Rezoning Transportation Analysis

Petition Number: 2025-126

| Date | Description |
|----------|-------------------|
| 12-22-25 | First Review (BH) |

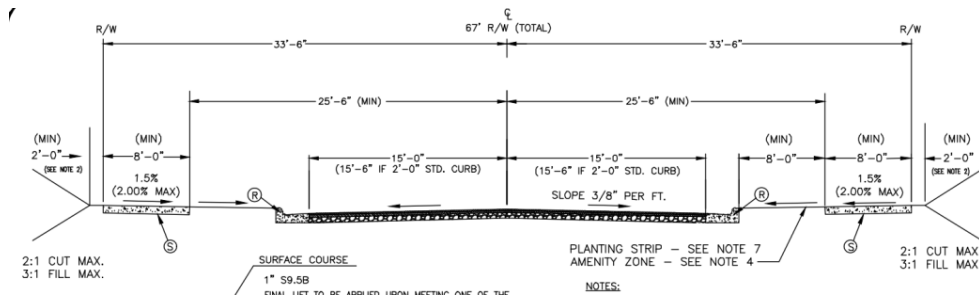
- a. **Wilora Lake Road:** Location of future back of curb and gutter is to be located 17.5 feet from road centerline and must be shown in the future location according to UDO Article 32.7 and 2040 Policy Map.

Local Residential Wide typical section with 8' sidewalk (CLDSM Standard No U-03A1).

Label and dimension the curb and gutter from the centerline for each road on the site plan.

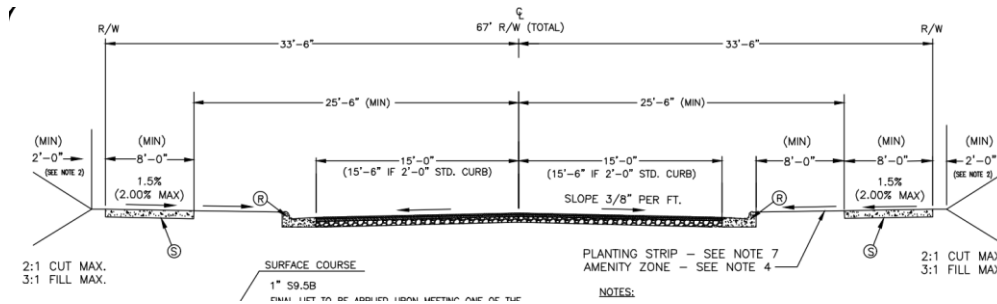
- b. **Mayberry Lane:** Location of future back of curb and gutter is to be located 17.5 feet from road centerline and must be shown in the future location according to UDO Article 32.7 and 2040 Policy Map.

Local Residential Wide typical section with 8' sidewalk (CLDSM Standard No U-03A1).

Label and dimension the curb and gutter form the centerline for each road on the site plan.

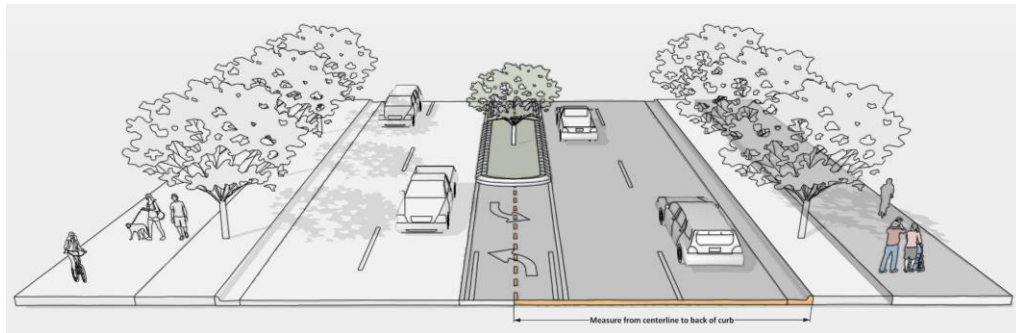
- c. **N Sharon Amity Road:** Location of future back of curb and gutter is to be located 30 feet from road centerline, and must be shown in the future location according to UDO Article 32.7 and 2040 Policy Map. Existing curb may remain in its current location.

Arterial 4+ Avenue with Shared Use Path (Charlotte Streets Map).

Label and dimension the existing and future curb and gutter form the centerline for each road on the site plan.

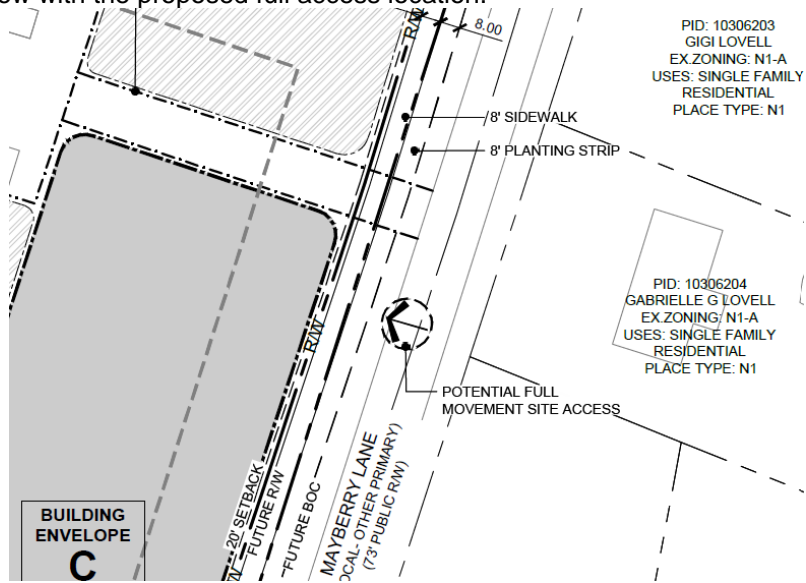
8. Align access arrow with the proposed full access location.

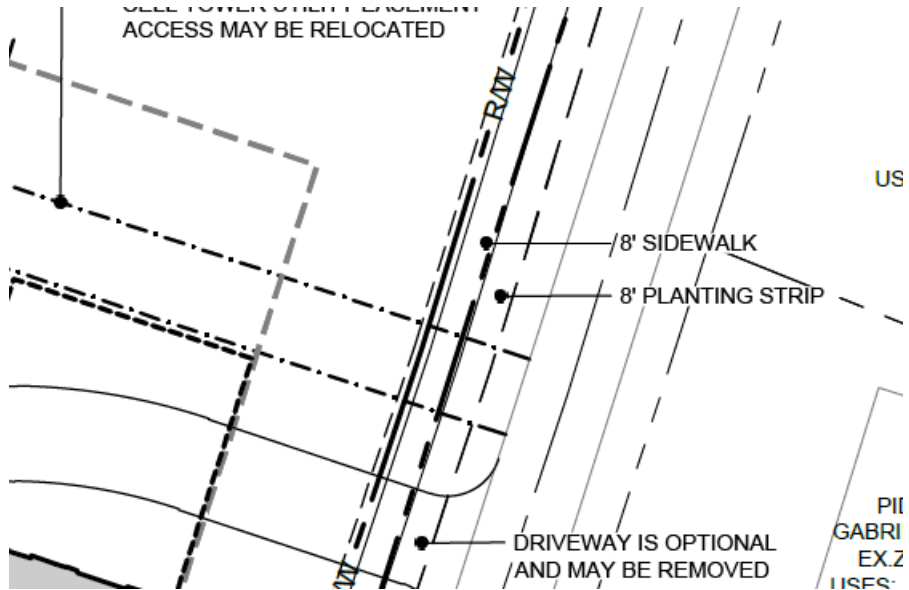
9. Clarify how the proposed cell tower utility easement is being accessed from Mayberry Lane.
